Subject: Review of Site Investigation Work Plan  
Community Within the Corridor – East Block  
2748 North 32nd Street, Milwaukee, WI 53208  
BRRTS #: 02-41-263675, FID #: 241025400

On April 19, 2021, the Wisconsin Department of Natural Resources (DNR) received *Site Investigation Work Plan*, dated April 14, 2021, prepared on your behalf by K. Singh and Associates, Inc. (K. Singh) for the above-referenced site. This submittal was presented with a Technical Assistance fee of \$700 for DNR review and response. On April 28, 2021, the DNR requested additional information regarding the potential sources of contamination at this site, and on April 30, 2021, the additional information was received (collectively, the SIWP). The DNR reviewed the SIWP for regulatory compliance with Wis. Administrative Code §§ NR 716.07 and NR 716.09, as this site is subject to regulation under Wis. Stat. ch. 292 and has determined that the SIWP cannot be approved at this time. The purpose of this letter is to present the DNR's review of the SIWP.

**Figure 6: 2758 N 33rd Street (Parcel #309-0503), Site Map**

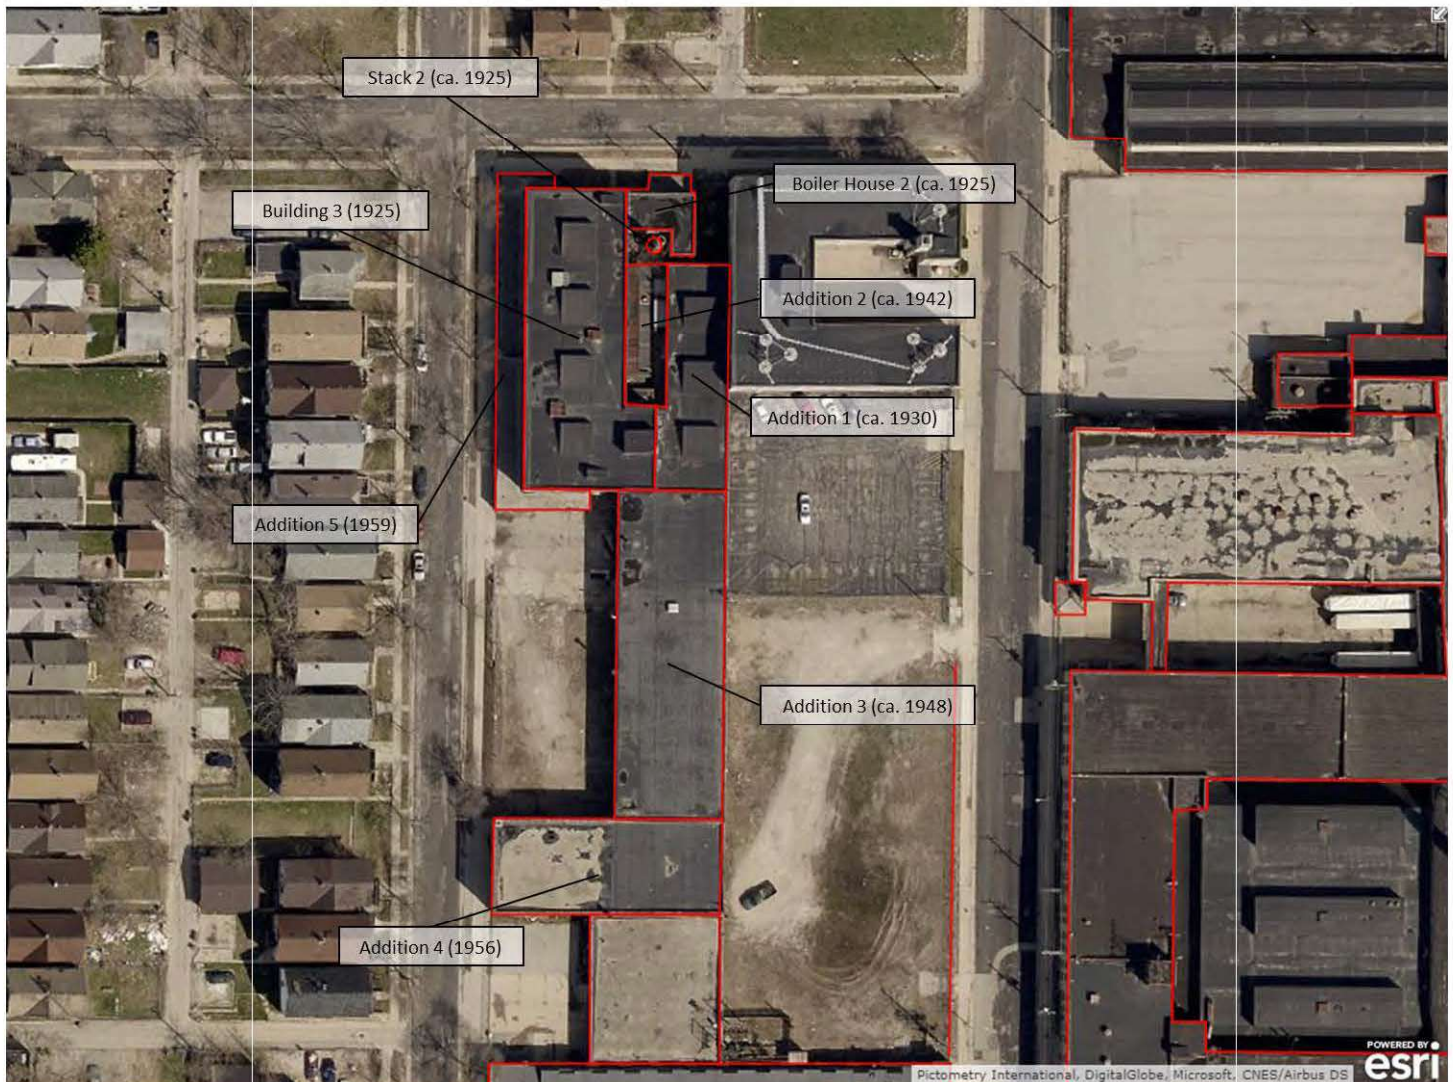
(ESs), and vapor risk screening levels (VRSLs). In the SIWP, K. Singh indicates the potential sources of the contamination that were not previously investigated as a part of the 2008 case closure are likely related to the historical industrial factory operations that occurred in building 1B (see *Briggs and Stratton Industrial Campus* figure, enclosed). According to the 1910 and 1926 Sanborn Maps (enclosed), historical operations in building 1B generally included painting, staining, sealing, and general use as a machine shop.

1. Soil investigation
  - a. The extent and degree and soil contamination has not been defined near the potential source areas in building 1B. Additionally, the proposed soil boring locations have not been adequately justified. It appears that several of the proposed soil boring locations are in areas of the site that have already been investigated and/or are not located near the potential sources of contamination in building 1B.

- i. Provide justification for each proposed soil boring location to explain how the location is expected to contribute to the goal of the site investigation. Furthermore, include additional soil boring locations near the potential sources of contamination in building 1B. Prepare updated figures, as applicable.

- ii. K. Singh previously indicated that it is not possible to perform sampling inside the building due to poor accessibility. If K. Singh concludes that sampling cannot occur in the building, then provide documentation (i.e., photos, discussion of building dimensions vs. equipment size, etc.) for the building as a structural impediment to the site investigation. Specifically include documentation for building 1B.

- iii. The potential sources of contamination are in building 1B and the area with the highest known concentration of contamination is in the western section of building 1B. If soil borings cannot be conducted inside the building to better define the potential source areas, additional soil borings should be placed along the sidewalk immediately to the west of building 1B to help to define the degree and extent of contamination related to the potential source areas in building 1B. Provide updated figures, as applicable.
